TECHNICAL NOTE

UPDATED JEDEC DDR2 SPECIFICATIONS

Figure 1: Extended Mode Register Control for On-Die Termination

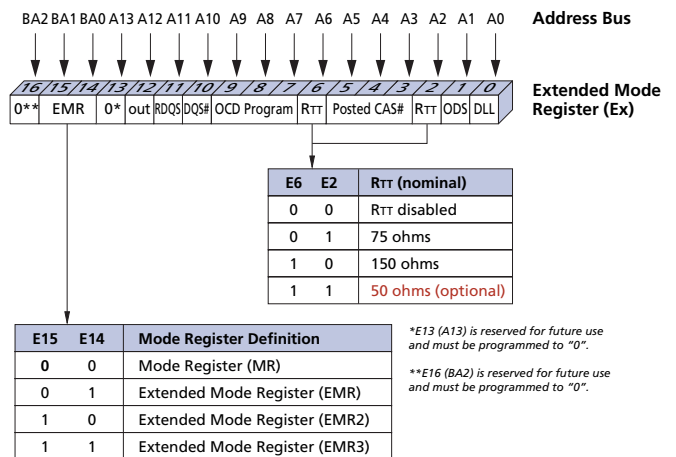
With a range of 40 ohms to 60 ohms, the 50-ohm ODT support is optional for all JEDEC-defined speed bins. The DDR2-400 and DDR2-533 design specifications do not require it; however, it will be mandated for several DDR2-667 and DDR2-800 platforms, in which the extended mode register's E2 and E6 bits select the 50-bit ODT when both are set to "1," as shown in Figure 1.

Figure 2: Delta VM Range

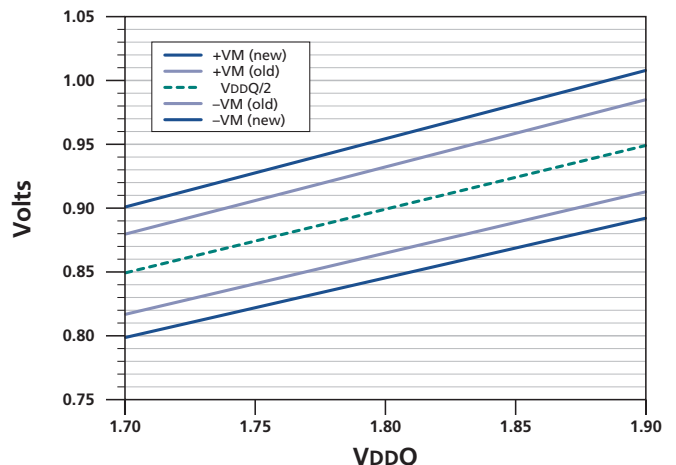
Delta VM is the percentage of voltage offset from the ODT's RTT voltage (pull-up resistor and pull-down resistor's voltages) with respect to VDDQ/2. The initial value of ±3.75 percent maximum deviation from VDDQ/2 was increased to ±6 percent to accommodate the third ODT value of 50 ohms. Figure 2 illustrates the range of VM offset allowed.

Figure 3: Mode Register Change

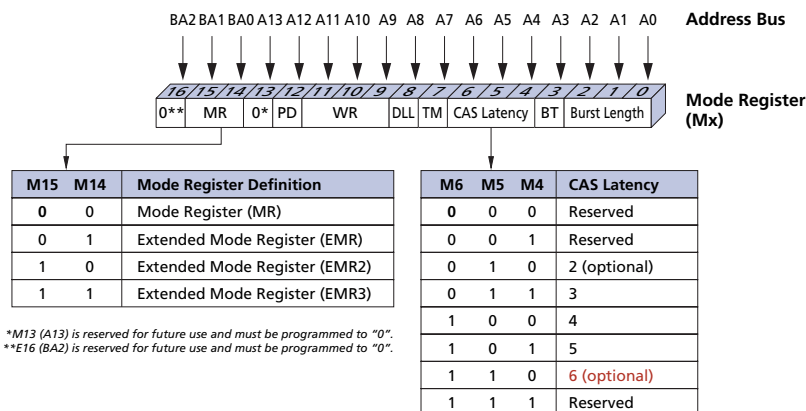
To support high-speed DDR2-800 speeds sooner, an optional CAS latency of 6 clocks has been added to the mode register, as shown in Figure 3.

Figure 4: Basic Power-Down Entry and Exit

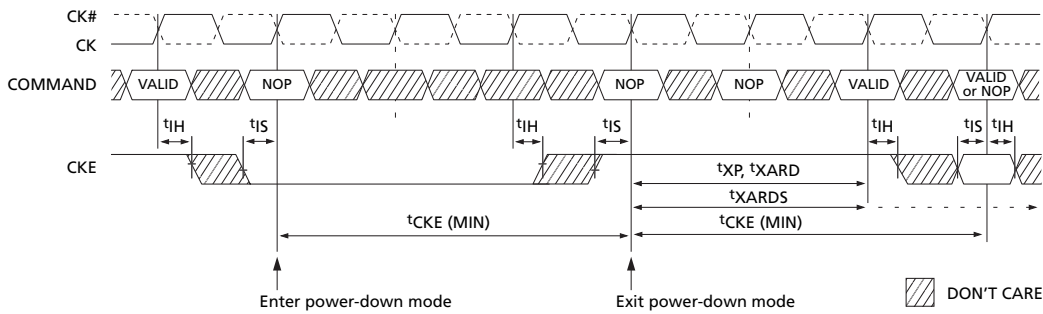
1. The definition was changed to refer to the device “clock registrations” rather than the “pulse widths LOW.”
2. The following note was added to the $t_{CKE} (MIN)$ definition:
 $t_{CKE} (MIN)$ of 3 clocks means CKE must be registered on 3 consecutive positive clock edges. CKE

must remain at the valid input level the entire time it takes to achieve the 3 clocks of registration. Thus, after any CKE transition, CKE may not transition from its valid level during the time period of $t_{IS} + 2 \times t_{CK} + t_{IH}$

3. The $t_{CKE} (MIN)$ waveform in the timing diagram was improved to provide clarity and remove ambiguity, as shown in Figure 4.

Figure 5: Command/Address Setup and Holds

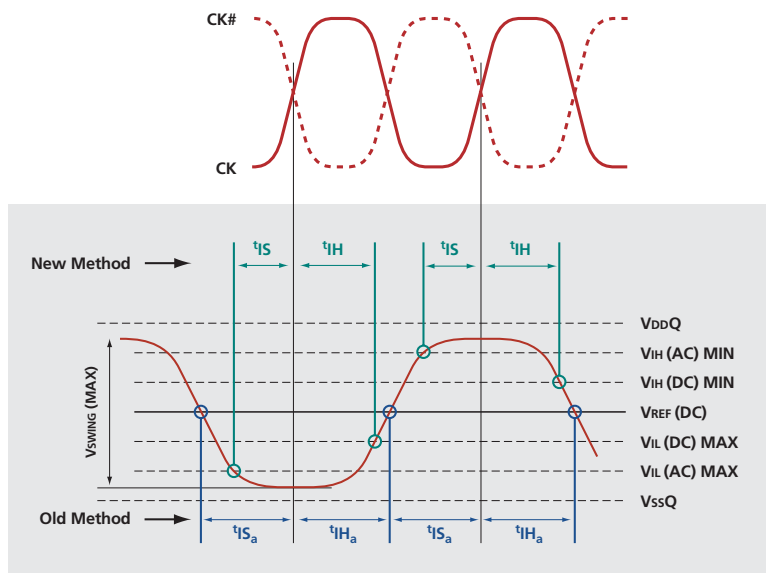
Previously, JEDEC specifications enabled symmetrical command/address setup and hold values by referencing the setup and hold timing specifications from the V_{REF} level, represented by the blue reference points in Figure 5, to the positive clock (CK and CK# crossing). However, when these types of setup and hold specifications are derated for slow slew rates—those less than 1.0 V/ns—too many picoseconds (ps) are either lost or overmargined. This is because a large degree of uncertainty is introduced and is dependent on the V_{REF} (dc) and V_{REF} (ac) noise present.

JEDEC approved a new methodology that references the command/address setup and hold timing from the appropriate logic level (the AC trip point for setups; the DC trip point for holds) to the positive clock's CK and CK# crossing, as indicated by the green reference points in Figure 5. Note that even though the specifications for the command/address setup and hold reference points and corresponding t_{IS}/t_{IH} base parametric values have changed, they still represent

If this change in reference points is overlooked when using the new smaller values, the command/address setup and hold windows will lose almost 400ps of margin. This occurs if the new method's input timing values are used along with the old method's V_{REF} reference points. For example, with a 1.0 V/ns input signal for DDR2-400, the previous setup and hold value was 600ps, while the new setup value is 350ps and the new hold value is 475ps. If the new setup and hold values are used correctly, they provide the same setup and hold times as the old method when the signals cross V_{REF} . However, if the new setup and hold values are used with the old V_{REF} method, the total setup and hold applied to the inputs is only 825ps, not 1,200ps. Thus, 375ps of timing requirement is lost (600ps + 600ps vs. 350ps + 475ps.)

Figure 6: Data Setup and Holds

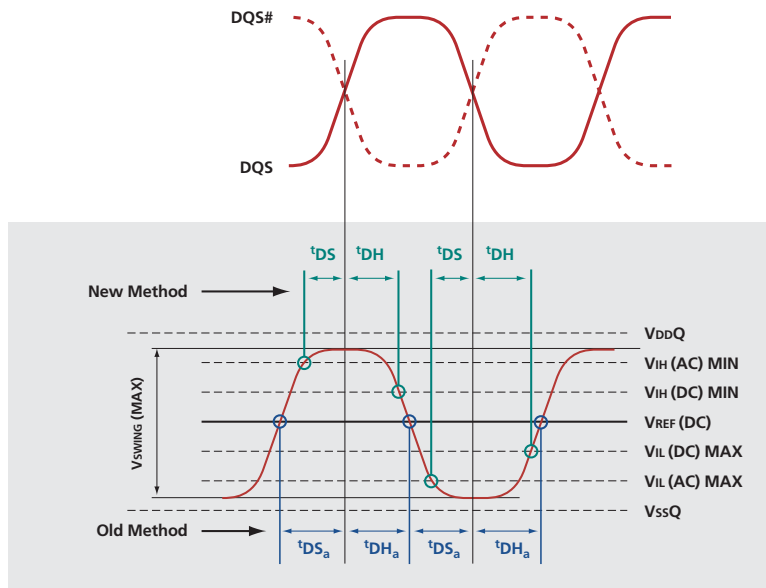
Previously, JEDEC specifications also enabled symmetrical data input setup and hold values by referencing the setup and hold timing specifications from the V_{REF} level to the positive clock (CK and CK# crossing), which are represented by the blue reference points in Figure 6. However, as with command/address input setup and hold timing, when these types of setup and hold specifications are derated for slow slew rates—again, less than 1.0 V/ns—too many picoseconds either get lost or overmargined. This is due to the large degree of uncertainty that is dependent on the V_{REF} (dc) and V_{REF} (ac) noise present. The V_{REF} noise becomes even more exaggerated at very slow slew rates, especially with nonlinear input signals, which may generate different timing results. The new methodology addresses these concerns by simplifying the measurement point outside of the V_{REF} region.

JEDEC approved a new methodology that references the data input setup and hold timing from the appropriate logic level (the AC trip point for setups; the DC trip point for holds) to the positive clock's CK and CK# crossing, as indicated by the green reference points in Figure 6. Note that even though the specifications for the data input setup and hold reference points and corresponding t_{DS}/t_{DH} base parametric

If this change in reference points is overlooked when using the new smaller values, the data input setup and hold windows will lose almost 400ps of margin. This occurs if the new method's input timing values are used with the old method's V_{REF} reference points. For example, with a 1.0 V/ns input signal for DDR2-400, the previous setup and hold values were 400ps, while the new setup value is 150ps and the new hold is 275ps. If the new setup and hold values are used correctly, they provide the same setup and hold times as the old method when the signals cross V_{REF} . However, if the new setup and hold values are used with the old V_{REF} method, the total setup and hold applied to the inputs is only 425ps, not 800ps. Thus, 375ps of timing margin is lost (400ps + 400ps vs. 150ps + 275ps.)

Figure 7: Extended Mode Register (2) With New High-Temperature, Self Refresh Option

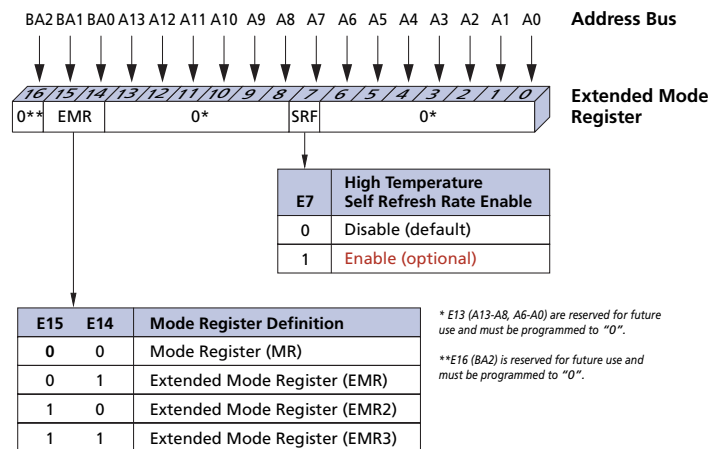
An optional new feature known as high-temperature self refresh rate enable (HTSR) has been added to the extended mode register (EMR2) that allows the user to operate the DDR2 SDRAM at temperatures above the +85°C T_C limit. HTSR is enabled by setting bit7 of EMR2—which normally must be set to a “0”—to a “1,” as shown in Figure 7. Because it has no upper limit standard, HTSR allows the DDR2 device to oper-

ate at the highest temperature limits defined by the part’s manufacturer, even if they are higher than the +85°C T_C specification limit. In such cases, the DDR2 SDRAM will refresh itself internally at a faster rate to accommodate the higher T_C limit.
